2021.11 Mass production inspection

Model Name: BFX-UA300

Document Version: ALT_STB_MP_CSMTINS_001

- Side LED not working
 - Issue grade : Critical
 - Symptom : R-Ch Side LED is not turn on
 - Defect unit Q'ty : 1pcs / 244pcs
 - Defect rate : 0.4%

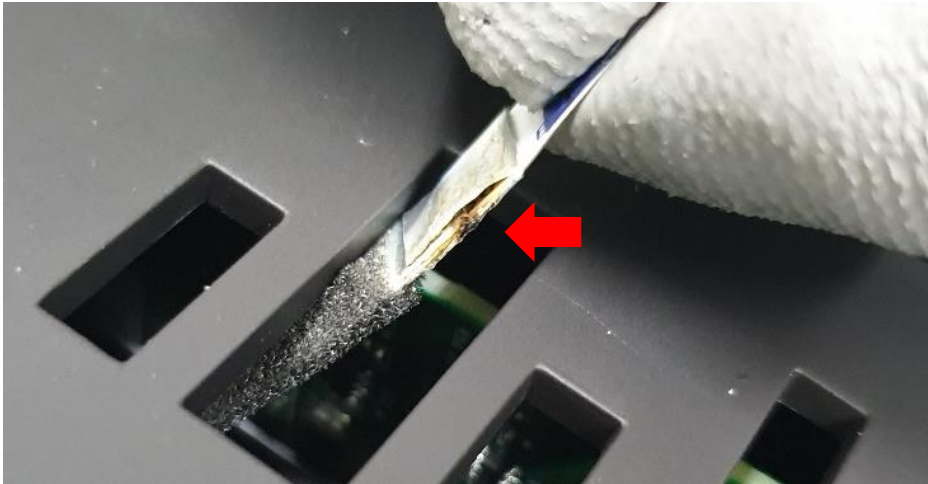
- ALT initial review
 - Disassembly Front grill, the FFC was damaged.
 - Disassembly side LED ass'y, the FFC connector broken due to top cover rib
- ALT Action
 - Replace the Side LED PCBA, FFC cable
- Factory Action item
 - FXN should be submit 8D report
 - Check and verify rib cutting result at the factory

- Grill attachment NG

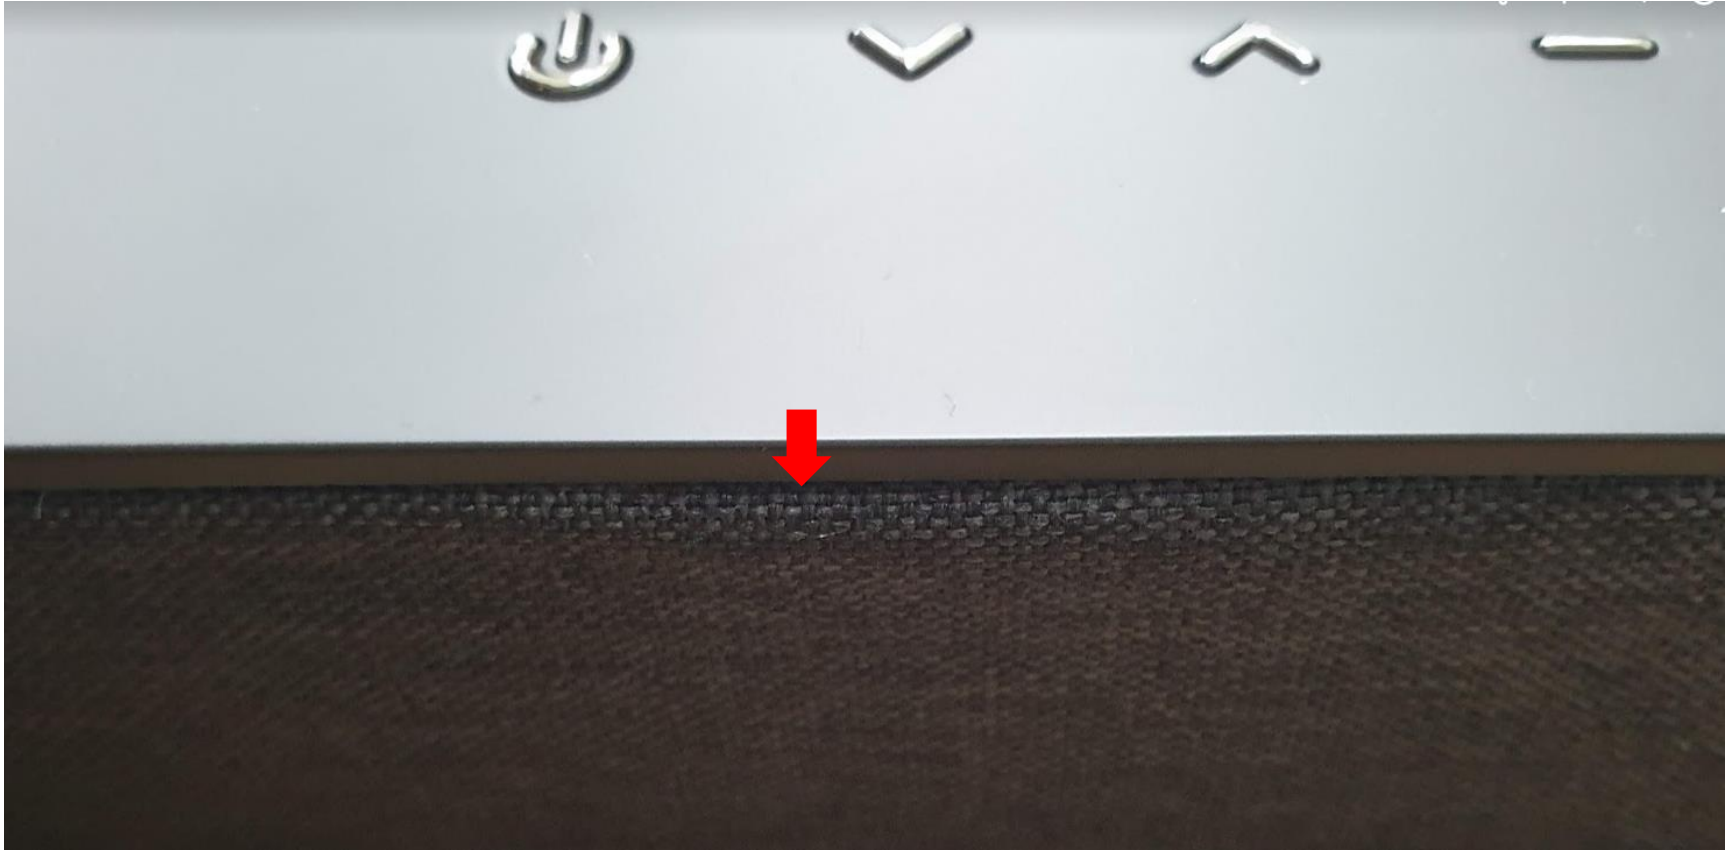
- Issue grade : Major
- Symptom
 - Attachment line NG
 - Defect unit Q'ty : 1pcs / 244pcs
 - Defect rate : 0.4%

SKB SN		mac	Note
214965001	202109002041	a8:93:4a:fe:80:02	grill fabric adhesive apply NG

- ALT initial review
 - Grill assembly quality improvement in progress
 - grill fabric adhesive apply NG
 - If the fabric does not adhere completely, It can cause vibration noise.
 - ALT will send to Vender 8D report to factory
- Factory Action item
 - Please add the CTQ point – IQC, PQC, OBA
 - Please check the cosmetic point, and contact Vender(Inkel) direct.
 - Vender will provide replacement parts.
